Spectrotek Services

Engineering Change Order – PA2-1

Units affected: Serial Numbers 2000 through 2132

Photo 1

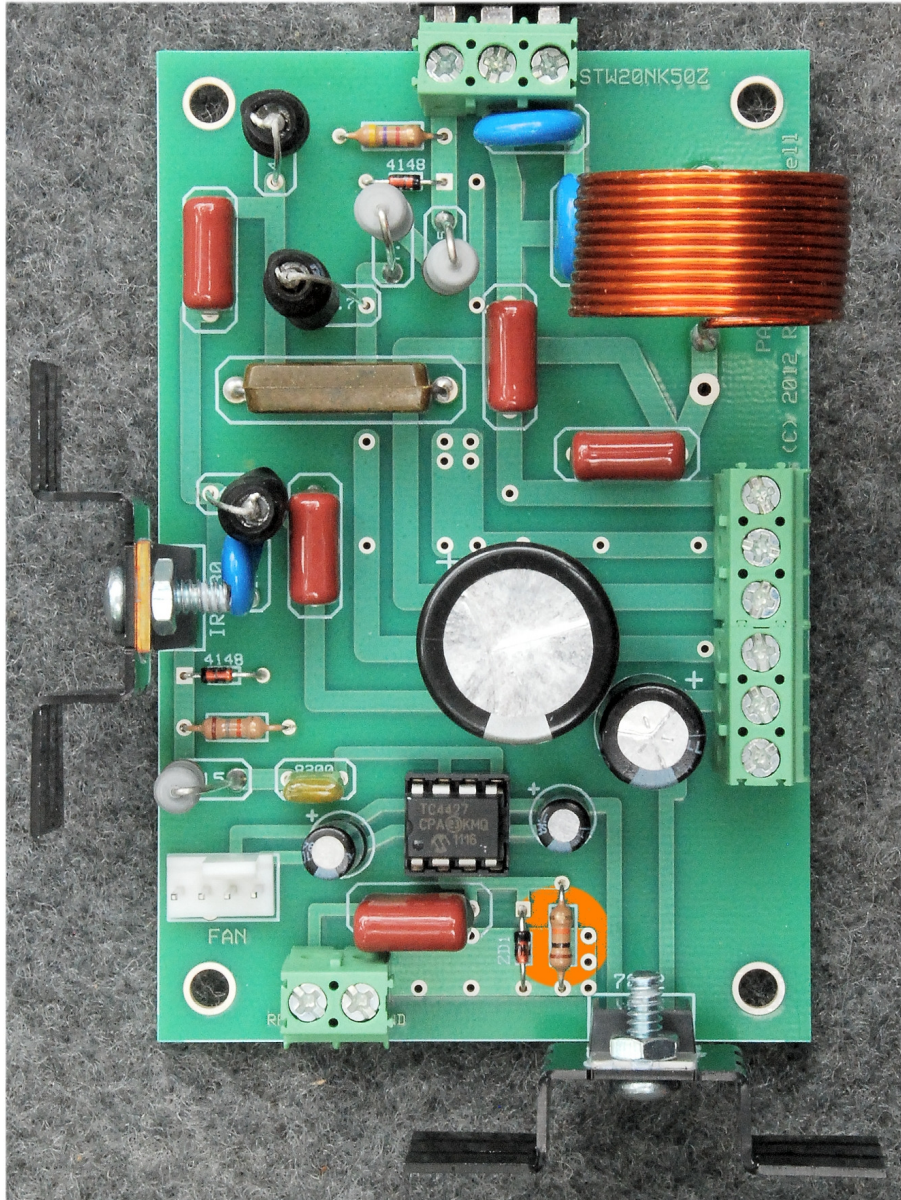
- 1) Random failure of the STW20NK50Z for no apparent reason.
- 2) Overheating or failure of the IRF730 for no apparent reason.
- 3) Unstable waveform on the leading or trailing edge of the modulation square wave.

Manufacturing variations in the input capacitance of the TC4427 MOSFET driver IC may cause an unstable bias condition to exist in the input amplifier of the TC4427. This instability results in a DC level shift, which changes the Schmidt trigger level, causing a series of incorrectly shaped output pulses from the TC4427. These pulses cause excessive current through the IRF730 and excessive drain voltage pulses to appear across the STW20NK50z, causing punch-through failure of the STW20NK50Z.

Please refer to the picture below for the position of resistor R1 which is highlighted in orange.

Replace existing resistor R1, 10,000 Ohms $\frac{1}{4}$ watt with a resistor of 470 Ohms, $\frac{1}{4}$ watt.

No other changes are required. No recalibration or adjustment of the modified PA2 is required after performing this ECO.
